STS-116 Integrated Delta Launch Site Flow Review

PRCB Presentation

Baseline the STS-116 Mission Specific Requirements and Flow Plans.

The STS-116 Integrated Launch Site Requirements were established by PRCBD S115116NR1 dated 07-11-06. CR S115116P and the Associated Data Package were reviewed at the 06-19-06 FRWG.

Item (1) M072-794500-004 IVHM Harness Installation Bay 13

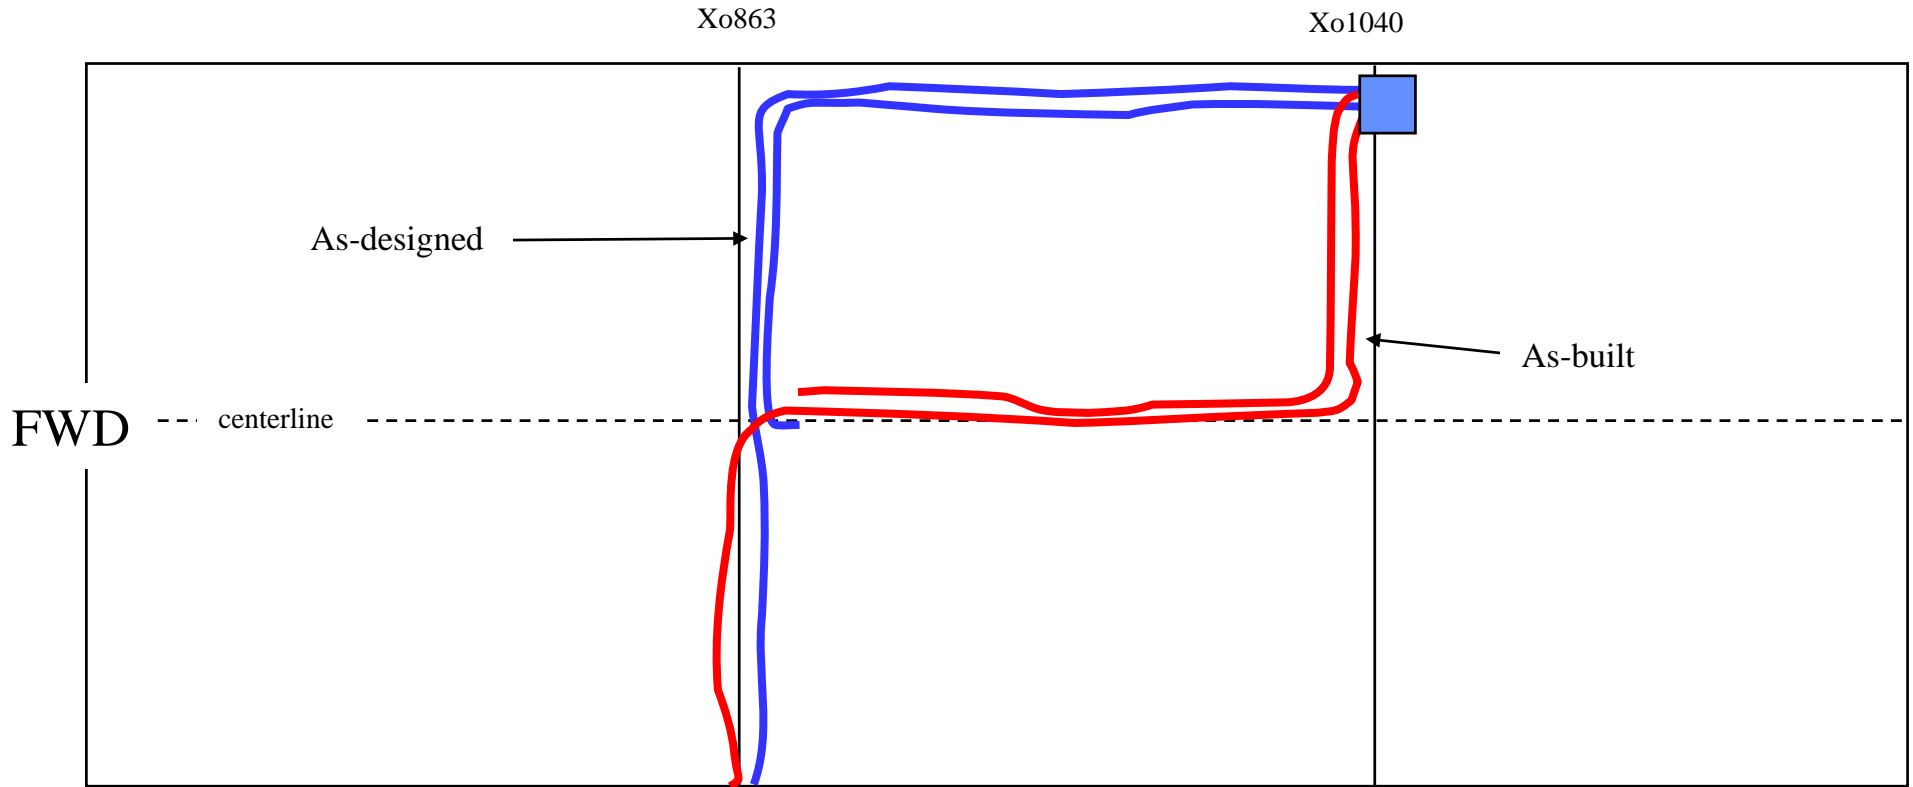
- Background
- M072-794500-004 IVHM Harness Installation Bay 13 called out by MECSLSI V072-200195
- During STS-114 processing this tech order configuration called for the removal of an un-used IVHM harness along with the routing hardware.
- At the time the tech order was made a requirement for flight 31, the bay 13 longeron had already been installed for flight.
- The harness was demated and stowed in place per MR and was deferred to a future flight at which time the bay 13 longeron will be removed.
- Since the bay 13 longeron was not removed this flight, a configuration waiver is needed for STS-116.
- Recommendation
- Approve Configuration Waiver for M072-794500-004

Item (2) M072-784633-014 Harness Installation-Interface Panel-MADS #3

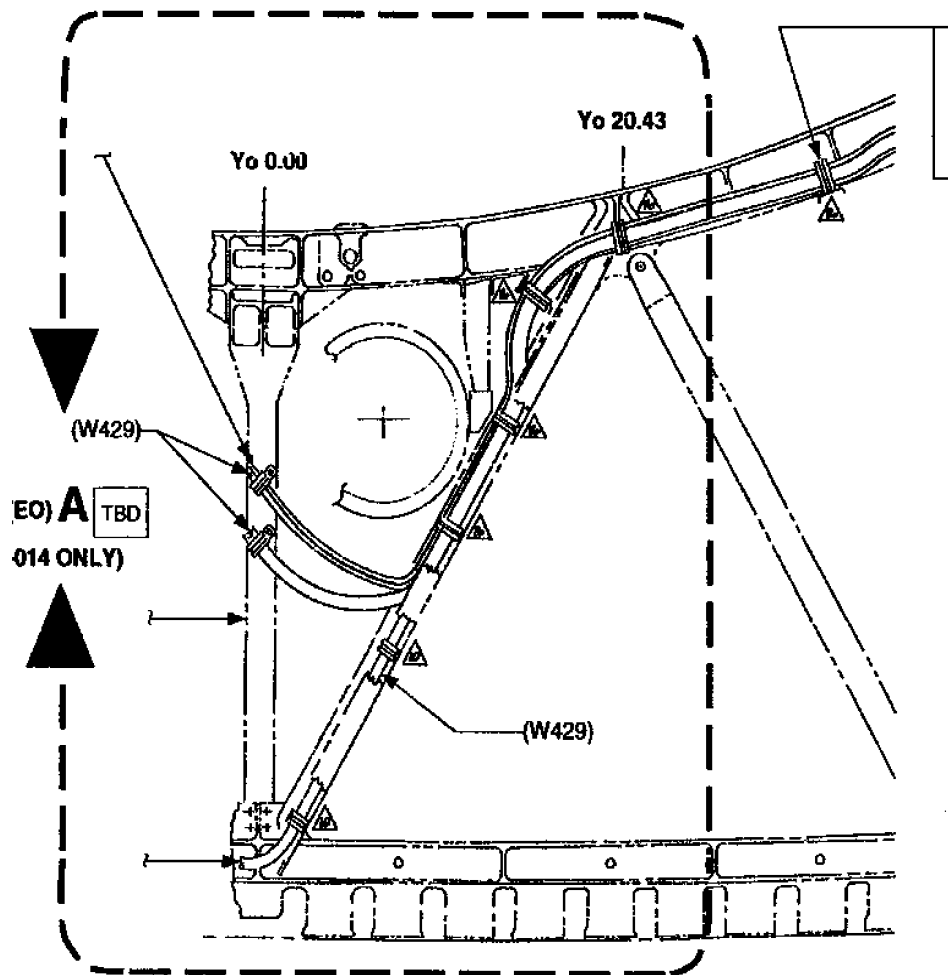
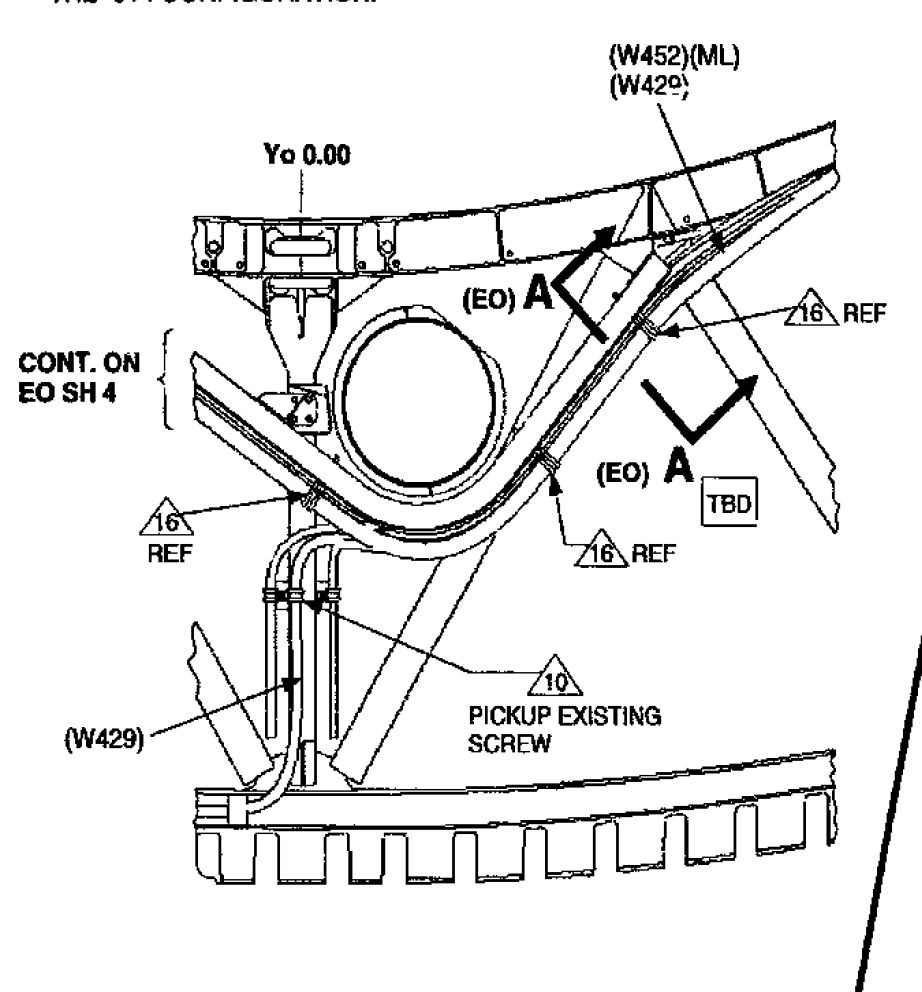
- **TPS OEL-3-31-245 incorporated the electrical portion of this modification per the vehicle drawings as well as the three tank set harness tech orders. During STS-114 processing, the WAD was reviewed and it was determined that an error exists in the M072-784633 engineering.**

- **This tech order reflects harness routing at the Xo863 that does not reflect the as-built configuration on the orbiter, see pages 13 & 14.**
- **- continued -**

- - continued -
- A one flight configuration waiver was processed and approved for STS-114 and STS-121.
- All hardware on this tech order is crit level 3.
- This tech order supports MADS wire routing, there were no observed wire routing violations noted during flight 31 midbody closeout and all MADS testing will be completed and verified.
- No technical issue with hardware, installation, or function of MADS.
- There was no access to this area this flow to perform wire routing as-built condition. A configuration waiver is needed for STS-116 for this tech order.
- Recommendation
- Approve Configuration Waiver for M072-784633-014
